Lindsay 2017 Developments Inc. / Sugarwood

Lot/Unit: 31 Phase/Building: 2 Model/Floor Plan: Cavendish Lake (4210) Elev A 4Bed 4.5Bath

SCHEDULE "B-1" Floor Plan

SKETCH #1

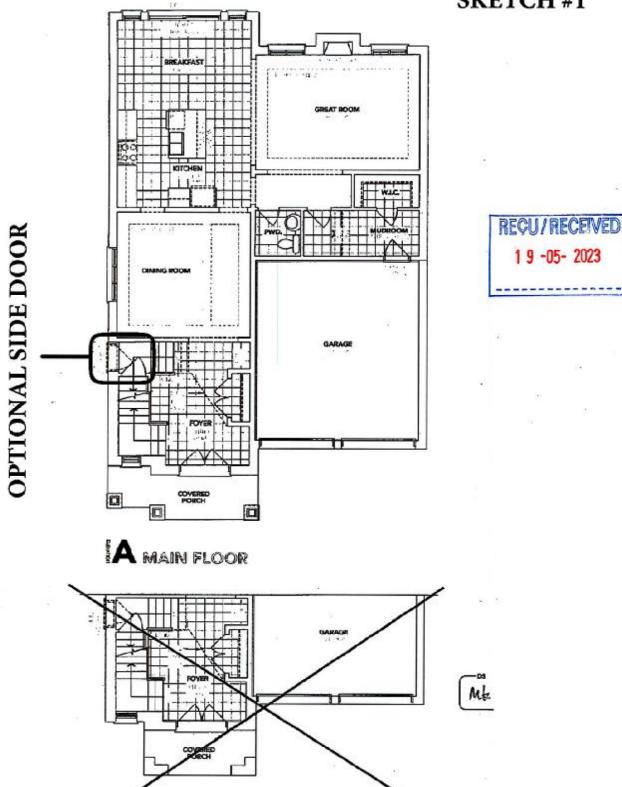
Inv. 6238	1 - TO SUPPLY AND INSTALL THE OPTIONAL SIDE DOOR SEE SKETCH #1	
Line 78944	Note:	
19May23 / 19May23

A BASEMENT

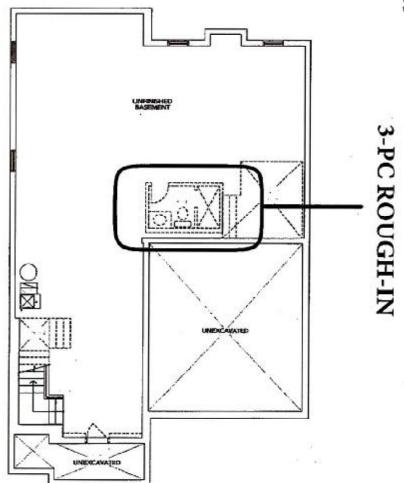
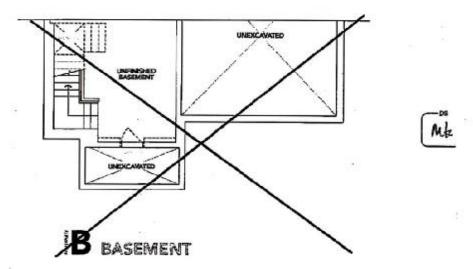
Inv. 6238	1 - TO SUPPLY AND INSTALL THE OPTIONAL 3-PC ROUGH-IN IN THE BASMENT SEE SKETCH #2	
Line 78945	Note:	
19May23 / 19May23
